TRUCK, UTILITY, LIGHTWEIGHT, FFR, MC 2 - LAND ROVER 110  
TRUCK, UTILITY, LIGHTWEIGHT, FFR, WINCH, MC 2 - LAND ROVER 110

ROLL OVER PROTECTION AND  
FITTING OF HEAD RESTRAINTS

MODIFICATION INSTRUCTION

FIG 1 - POSITION OF CAPPING PLATES, REAR BRACE AND GUSSET

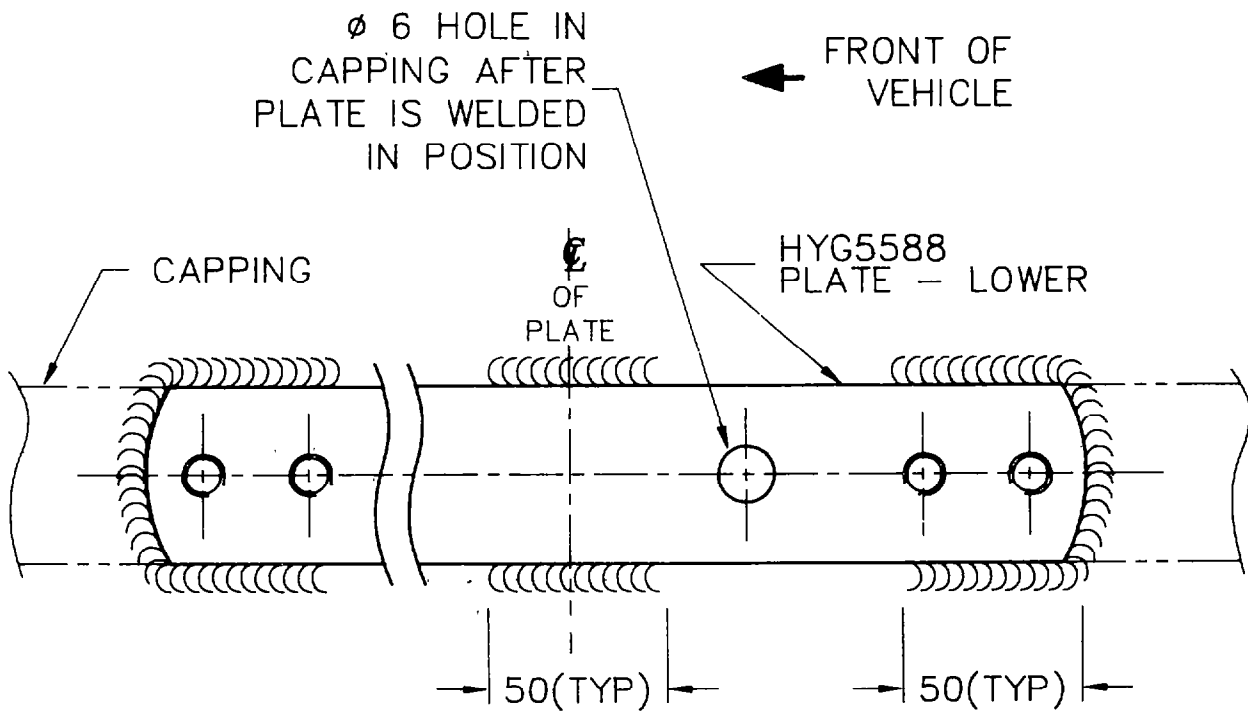
- j. Bolt capping plates (item 1e and 1f from Table 1) together to ensure correct alignment and maximum thread engagement is achieved.
- k. Position capping plates and rear braces (item 1a and 1b from Table 1) to obtain a flush fitting of rear braces to existing roll tube and upper capping plate ensuring a 16 mm clearance from pipe end to bolt centre as shown in Fig 1 is achieved.

- m. Position bolted plates and rear brace and tack weld lower plate to capping ensuring plate is in line with Top of Radius bend as shown in Fig 3 and the 16 mm clearance from pipe end to bolt centre as shown in Fig 1 is achieved.

- n. Tack weld rear braces to upper plates and existing roll tube.
- o. Position gusset (item 1g from Table 1) centrally to both rear brace and upper plate, ensuring that the bolts can be accessed with a ring spanner and tack weld into position, as shown in Fig 1.

- r. Mark and weld lower plate to capping as shown in Fig 2.
- s. Fully weld rear brace to upper capping plate and existing roll tube.
- t. Fully weld gusset as shown in Fig 1.

FIG 2 - WELD DIMENSIONS LOWER PLATE TO CAPPING

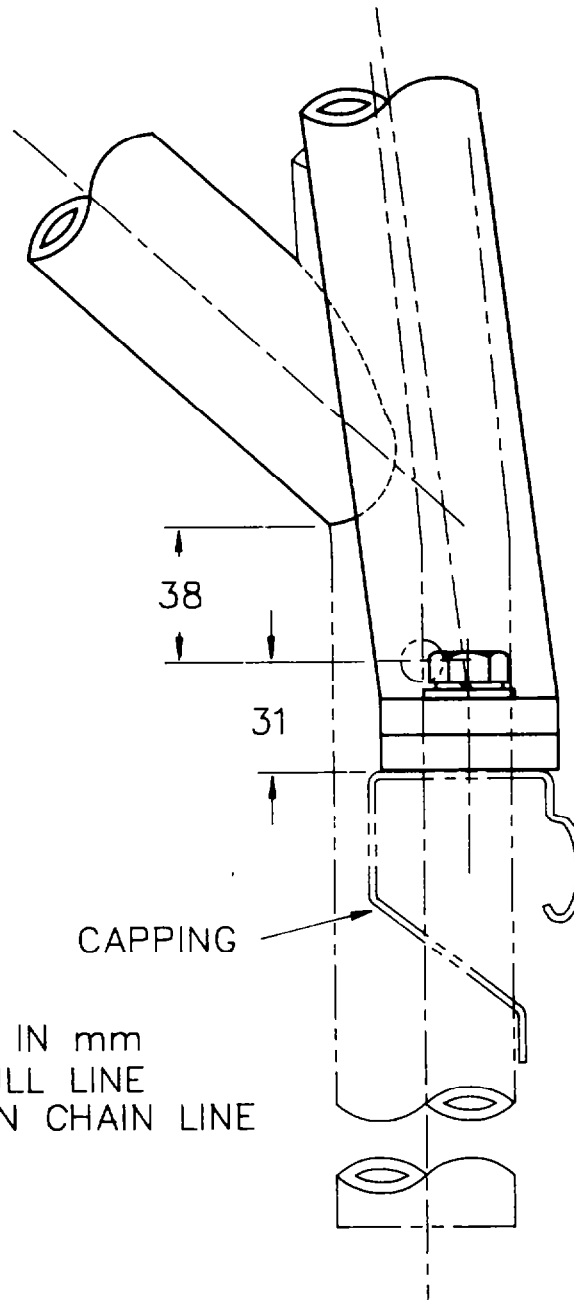
- aa. Drill a 6 mm hole in each capping rail as detailed in Fig 2.
- ab. Lower roll tube assembly and replace all mounting bolts, capping plate bolts are to be secured with Loctite 277.
- ac. Clean all welds and paint all exposed surfaces with primer, zinc rich epoxy and allow to dry, then apply olive drab (item 4 from Table 1) as a finish coat.

FIG 4 - POSITION AND WELD DIMENSIONS FOR SHEAR PLATE

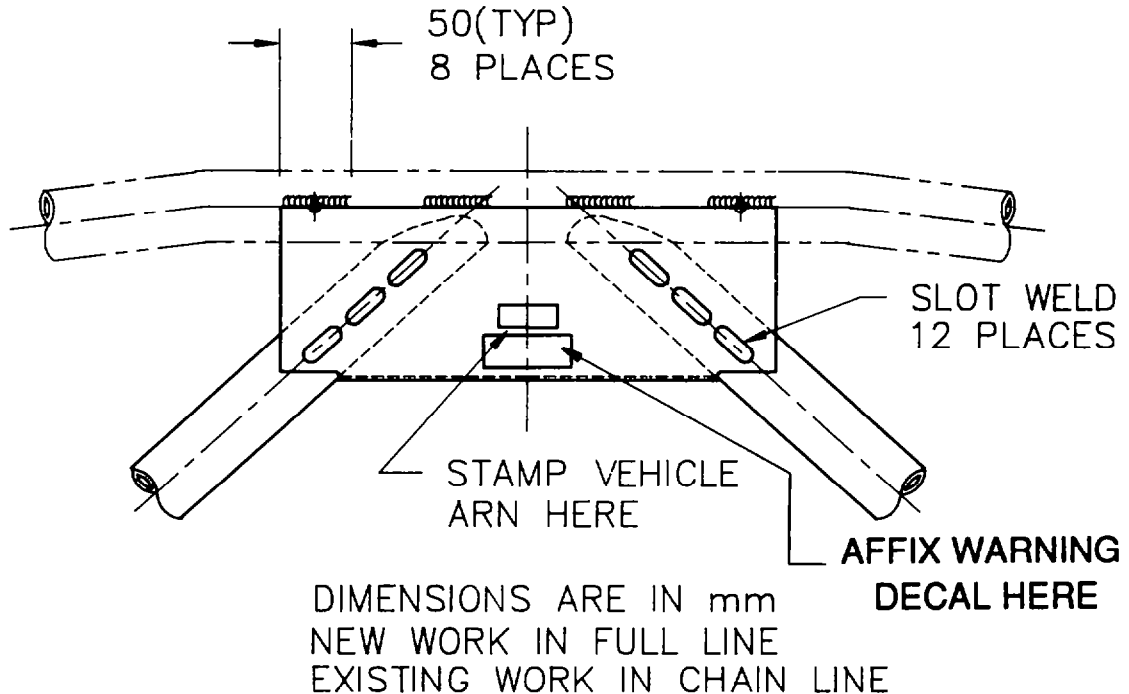
- ad. Replace seat belts on the upper mounting position of the roll tube.
- ae. Replace cargo seat frames.
- af. Replace the two horizontal canopy rails.
- ag. Replace the canopy and cam net carrier.
- ah. Reconnect the battery.
- ai. Using 1/4 inch metal stamps, clearly mark the vehicle ARN on the rear of the shear plate as detailed in Fig 4.

- aj. Fit warning decal (Item 1k from Table 1) as shown in Fig 4.

FIG 5 - FITTING OF HEAD RESTRAINTS

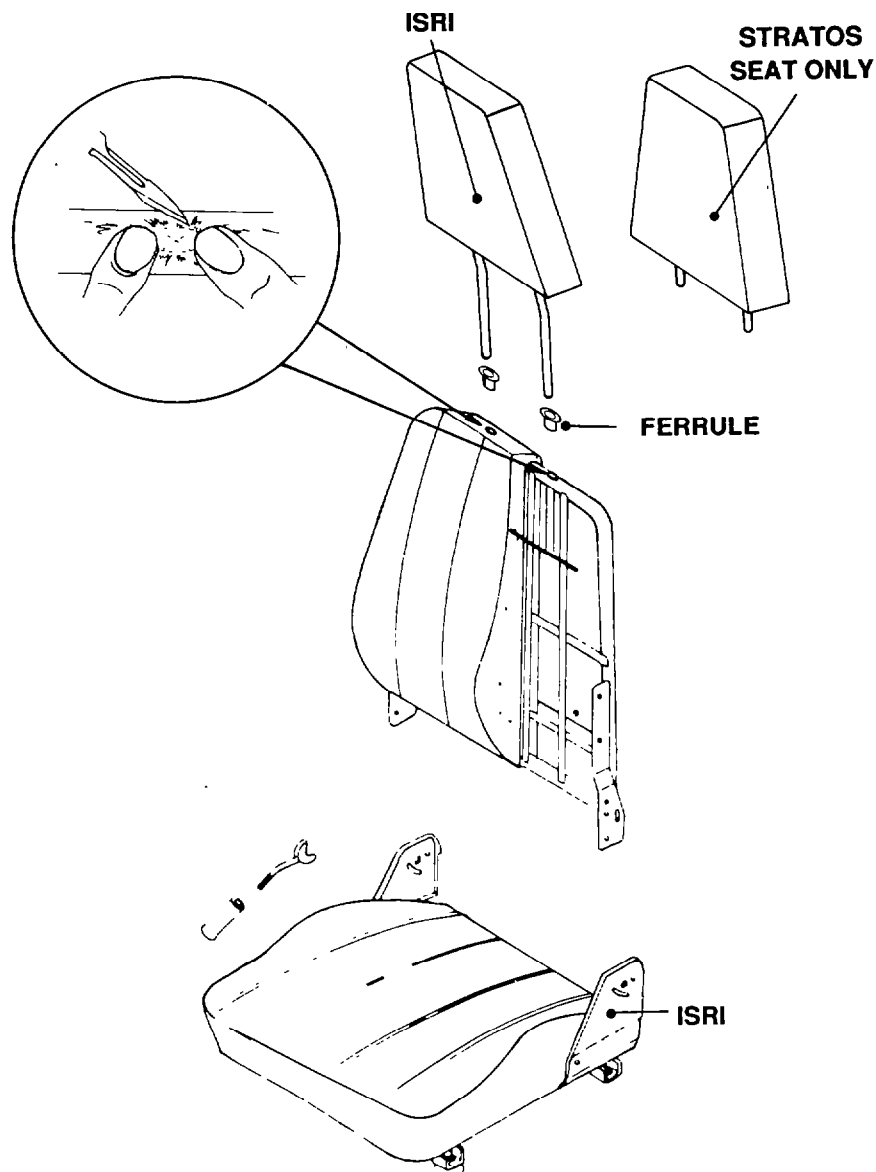
9. There are two types of head restraints suitable for either the ISRI or Stratos manufactured seats. The ISRI seat is identified by letters 'ISRI' marked on the seat squab back pivot plate as detailed in Fig 5., the Stratos seat does not have a pivot plate or markings.

- a. In both seat types there are two vertical tubes located beneath the vinyl trim in the seat squab back as shown in Fig 5.
- b. Locate the tubes by feeling for them beneath the vinyl and when located carefully cut vinyl with a sharp instrument to expose the apertures as shown in Fig 5.
- c. On ISRI seat only fit ferrules (Item 1n from Table 1) by placing over tubes and forcing downwards until flush with the seat squab.
- d. Fit head restraints into tubes until flush with the seat squab.

FIG 6 - COMPLETED MODIFICATION  
(LESS HEAD RESTRAINTS)

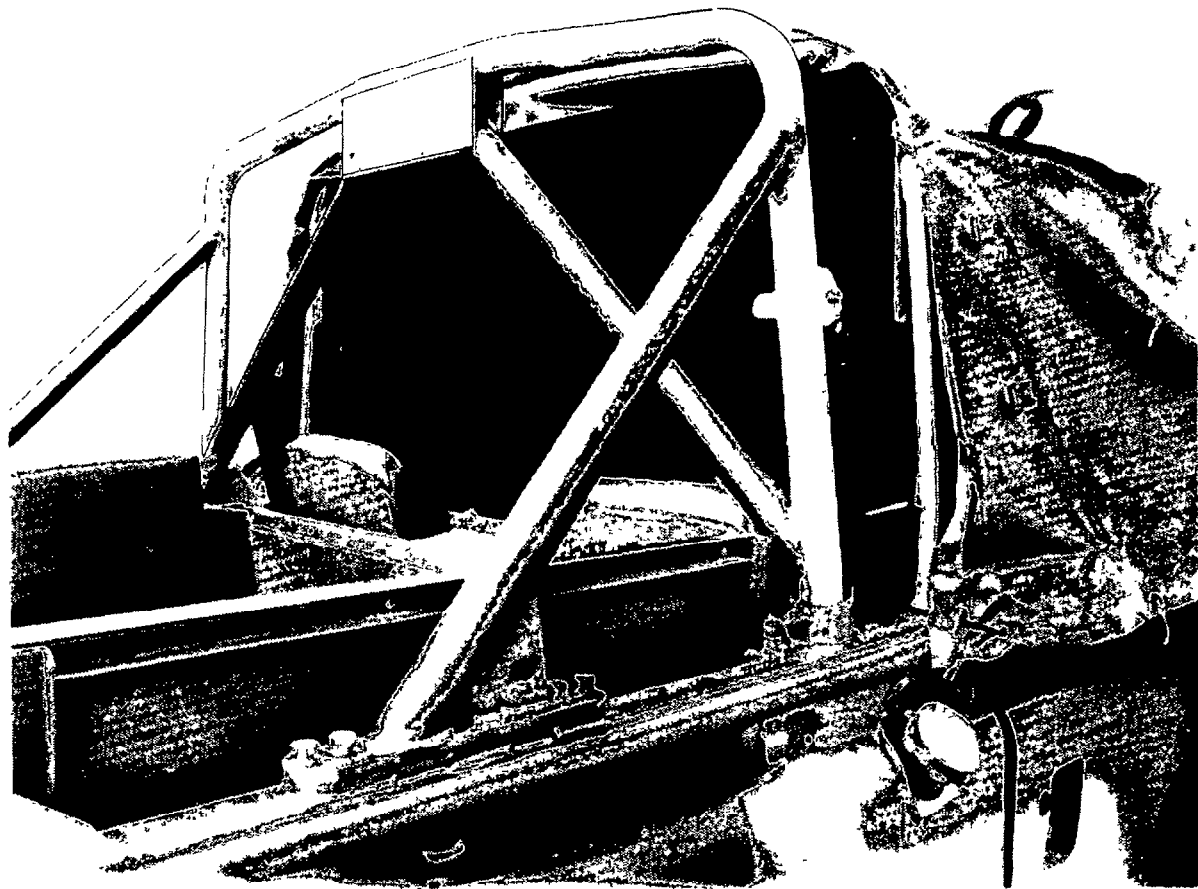
8. The completed modification is shown at Fig 6, with the engineering assembly drawing (MEA drawing No 1565) shown at Fig 7 and is to be completed strictly in the sequence as described below:
